REFERENCE:	TSB: 08-148-23 REV. A GROUP 08 - Electrical	Date:	June 23, 2023	REVISION:	08-148-23
VEHICLES AFFECTED:	2023 (GG) Dodge Hornet This bulletin applies to vehicles built on or before May 30, 2023 (MDH 0530XX).	MARKET APPLICABILITY:			
		<input checked="" type="checkbox"/> NA <input type="checkbox"/> MEA <input type="checkbox"/> SA <input type="checkbox"/> IAP <input type="checkbox"/> EE <input type="checkbox"/> CH			
CUSTOMER SYMPTOM:	<p>Customers may experience a Malfunction Indicator Lamp (MIL) illumination. Upon further investigation the technician may find that the following DTC has been set:</p> <ul style="list-style-type: none"> C0529-00 - Steering Angle Sensor Module Missing Calibration - No Subtype Information. <p>The customer may experience the following:</p> <ul style="list-style-type: none"> During a key OFF and ON action, rotating the steering wheel without any power assist, the Malfunction Indicator Light (MIL) ON will be activated due to a loss of calibration of the steering angle sensor. After turning the steering wheel lock to lock, the MIL will be switched off.

This bulletin supersedes Technical Service Bulletin (TSB) 08-148-23, date of issue June 17, 2023,

Fig. 1
Example of wiTECH Step Flashes

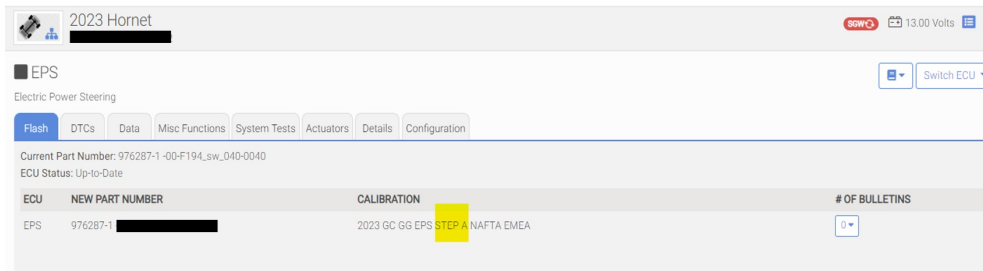
CAUTION! **Multiple step flashes up to three may be necessary and are required to completely update this EPS these must be performed in order starting with STEP A or B and ending with Step C, be sure to follow wiTECH accordingly (Fig. 1) .**

- **Select the appropriate software per wiTECH (Step A, B or C) either Step A or B must be done first in order and end with Step C when finished.****
- Reprogram the EPS module with the latest software. Detailed instructions for flashing control modules using the wiTECH Diagnostic Application are available by selecting the application’s “HELP” tab.
- Wait 2 minutes after the EPS flash has been completed.
- To perform an EPS reset with wiTECH - Go to the Guided Diagnostics menu --> Select Reset ECU --> Select "EPS" from the list of modules --> Click "Continue" at the bottom of the page then follow the wiTECH prompts.
